# Replacement System Variance Request

APPLICATION FOR SUBSURFACE WASTEWATER DISPOSAL PERMIT

DETAILED SPECIFICATIONS FOR STEPHEN HOAD'S RESIDENT  
ON THE PULLEN ROAD, AUGUSTA, MAINE

Re: Replacement Subsurface Wastewater Disposal System Hoad Property,  
Pullen Road, Augusta

Subsurface Wastewater Disposal Plan

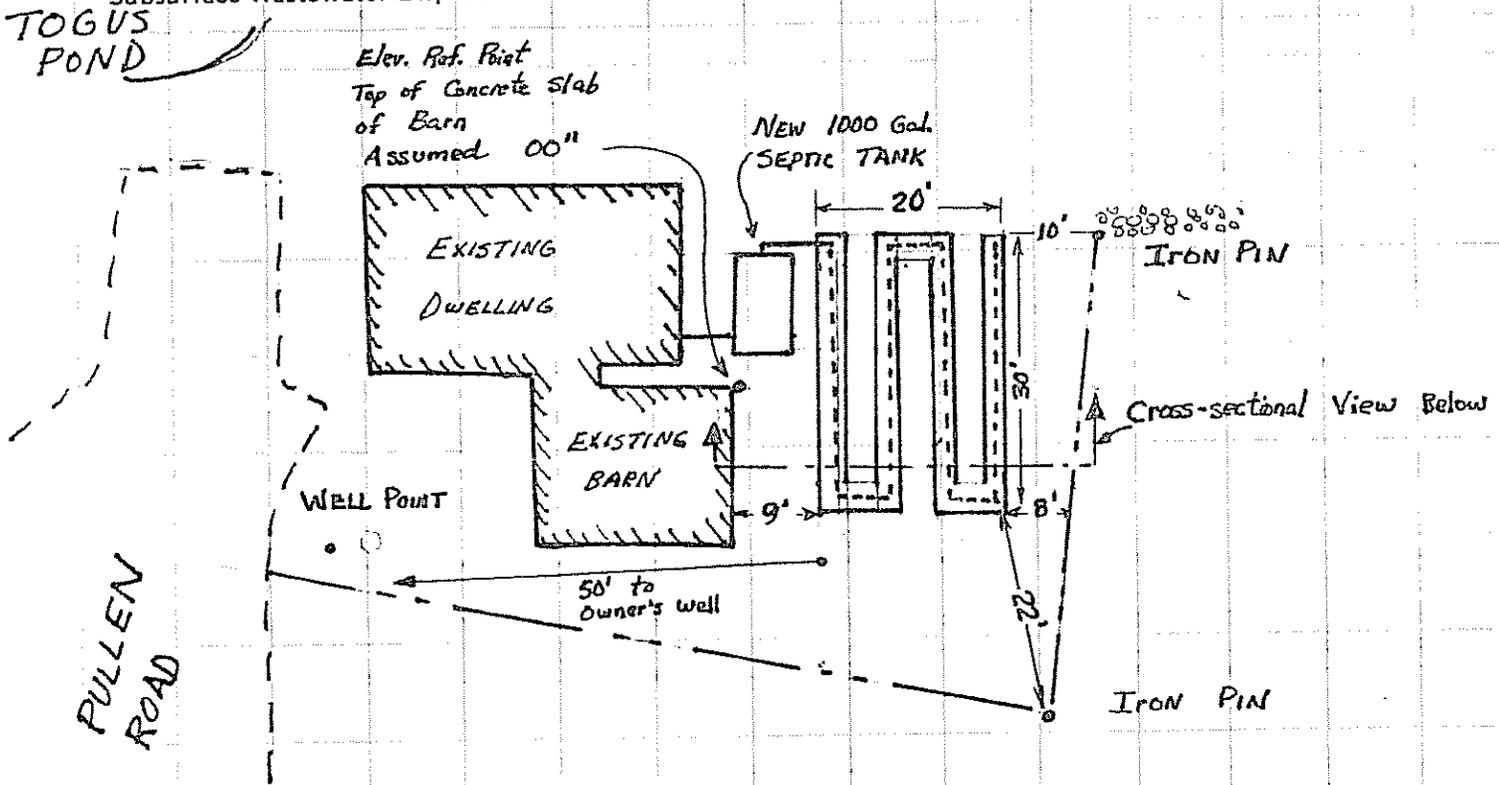
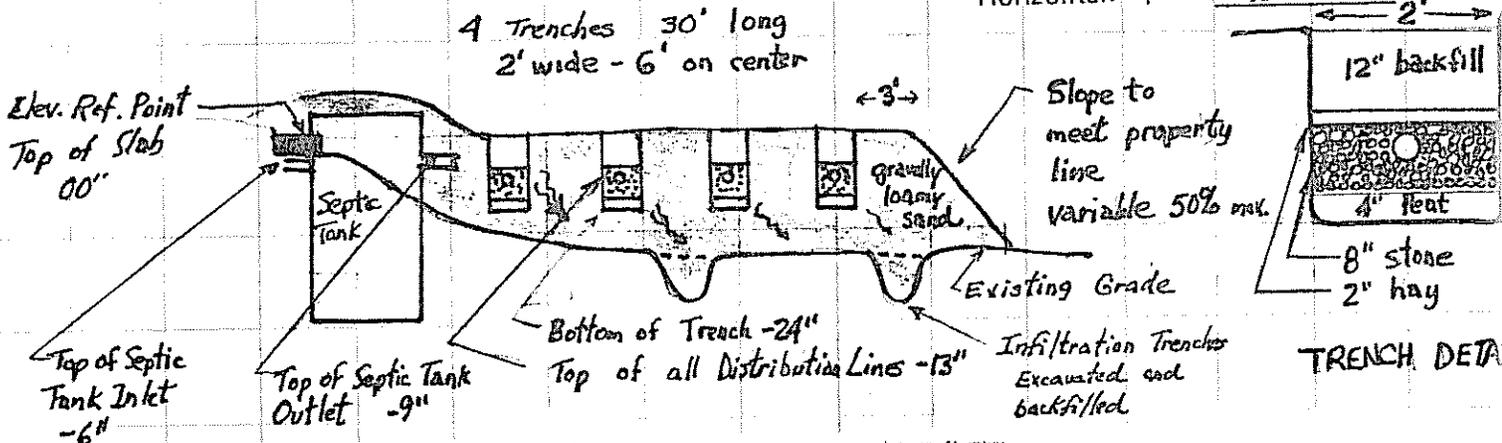
It is our opinion that the proposed disposal system design is the most practical system when considering:

1. the severe site limitation with seasonal high ground water table and limited area
2. proximity to swamp
3. proximity to your well
4. financial considerations.

Due to the above mentioned factors, a disposal system could not be installed in complete compliance with the Rules. The proposed system should provide adequate treatment to dispose of the wastewater in an environmentally sound and sanitary manner provided the users respect the system and its limitations. However, no guarantee is implied or inferred due to the nature of the conditions.

1. The proposed design assumes that significant internal plumbing modifications are to be done and that the plumbing can be adequately raised to allow for gravity feed into the disposal system. If this is not done or impossible, then a pump will be required.
2. Flow reducing fixtures and low volume toilets and water saving devices and/or practices should be employed.

3. A deed covenant shall be accepted documenting the nature and condition of the replacement disposal system.
